## PLAT COMMITTEE

**Case Number:** 2023-PLT-089  
**Property Address:** 5202 & 5240 Pike Plaza Road (*Approximate Address*)  
**Location:** Pike Township, Council District # 10  
**Petitioner:** Kesler Limited Partnership, by Paul J. Lambie  
**Zoning:** C-5 (FF) (FW)  
**Request:** Approval of a Subdivision Plat, to be known as Kesler Plat, dividing 7.55 acres into two lots, with a waiver of the sidewalk requirement along Pike Plaza Road and Lafayette Boulevard.  
**Waiver Requested:** waiver of the sidewalk requirement along Pike Plaza Road and Lafayette Boulevard  
**Current Land Use:** Undeveloped / Parking  
**Staff Reviewer:** Allison Richardson, Senior Planner

## STAFF RECOMMENDATION

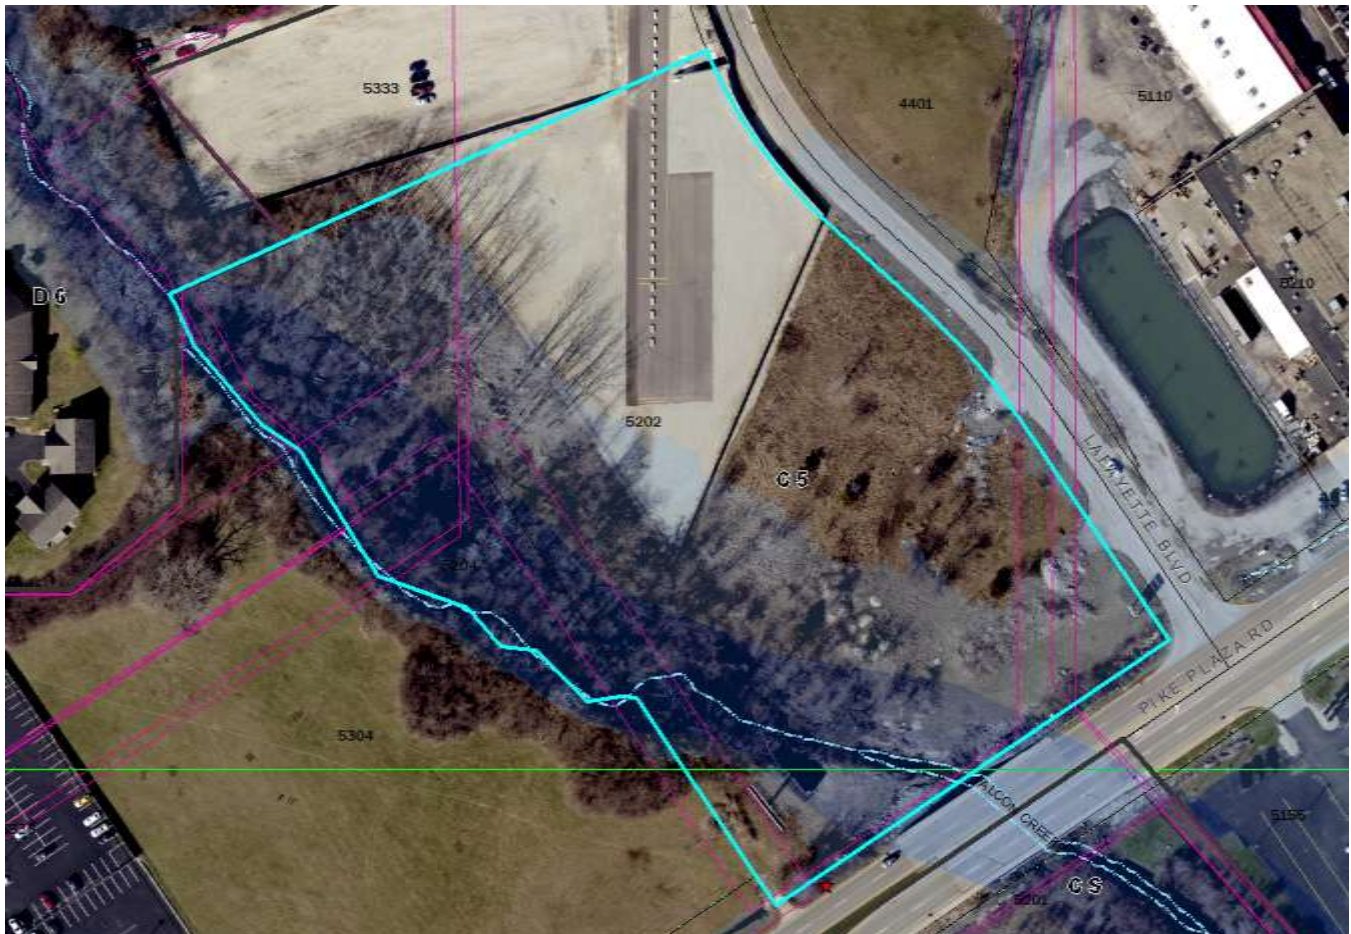
Sidewalks would be required to be installed along Pike Plaza Road and Lafayette Boulevard per the ordinance. There is a drainage ditch along Pike Plaza Road; however, there is a bridge including a sidewalk over Falcon Creek on the south frontage, which would suggest that installation of sidewalks is possible. There is also evidence of people walking on this frontage per the Google Street View image below, indicating that pedestrian infrastructure is needed. There are no topographic challenges for installing sidewalks along Lafayette Boulevard. Therefore, staff is recommending denial of the waiver.

If the plat committee approves the waiver against staff's recommendation, a contribution in lieu of sidewalk installation should be required as a condition of approval subject to Section 744-301.G.
